JERRY W. HIATT, CHP
Certified Health Physicist
Sr. Project Manager

October 1, 2015

Subject: Industry Comments on the NRC Advance Notice of Proposed Rulemaking (ANPR) for 10 CFR Part 50, Appendix I, Docket ID NRC-2014-0044

Figure 3.15

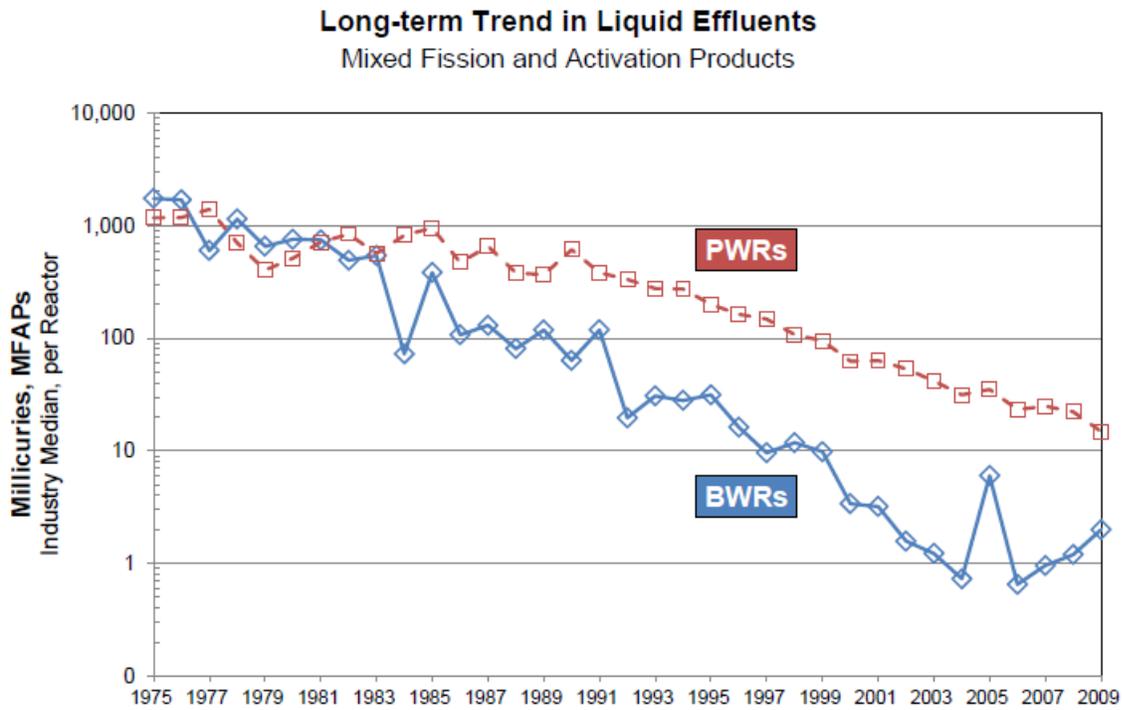
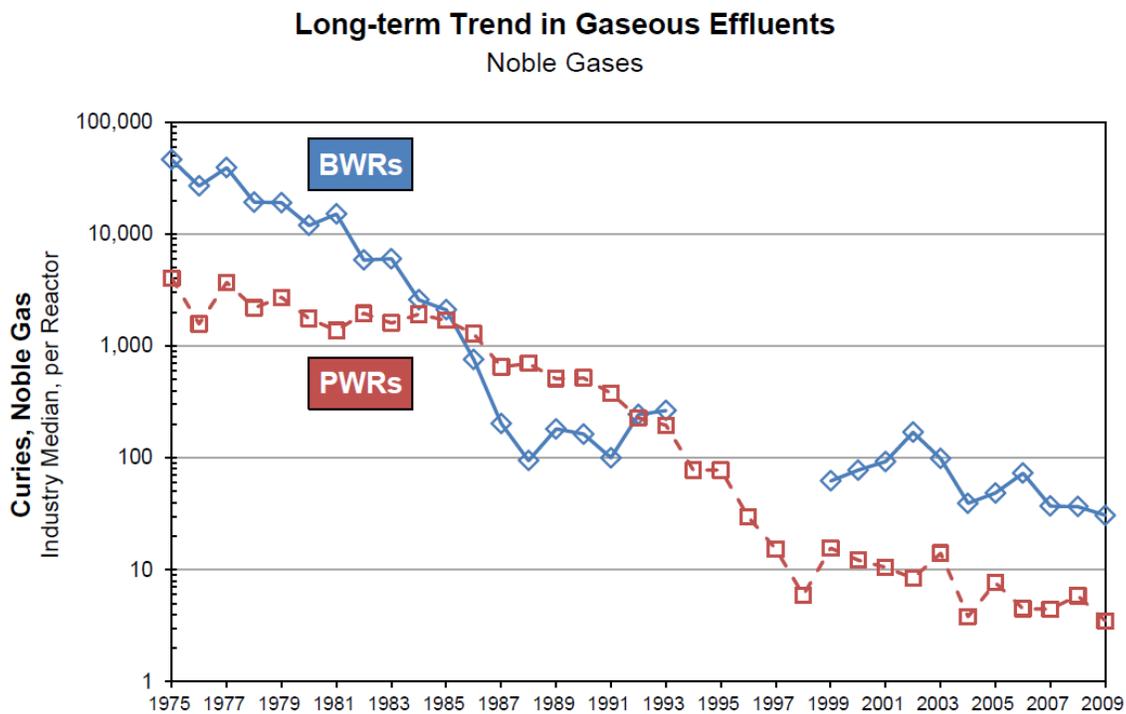
As stated in SECY-08-0197, “current regulations provide adequate protection of public health and safety and are well understood by licensees, and that the impacts of changing the regulatory framework are not balanced by the benefits of updating scientific information and enhancing international consistency”³⁰. Additionally, Enclosure 3 to SECY 08-0197, also states that “the implementation of Part 50 Appendix I design objectives is not an issue for power reactors because their use is well established and the industry has extensive operational experience in demonstrating compliance.”³¹ Regulatory compliance is documented in NUREG/CR-2907, Vol. 15, *Radioactive Effluents from Nuclear Power Plants*, where compliance is demonstrated below with figures 3.15 and 3.18 (from NUREG/CR-2907) displaying this improving trend graphically:³²

The figures above demonstrate that the median dose calculated from both liquid and gaseous releases is well below 1 millirem per year. Giving context to the significance of 1 millirem per year NUREG/CR-2907 provides:
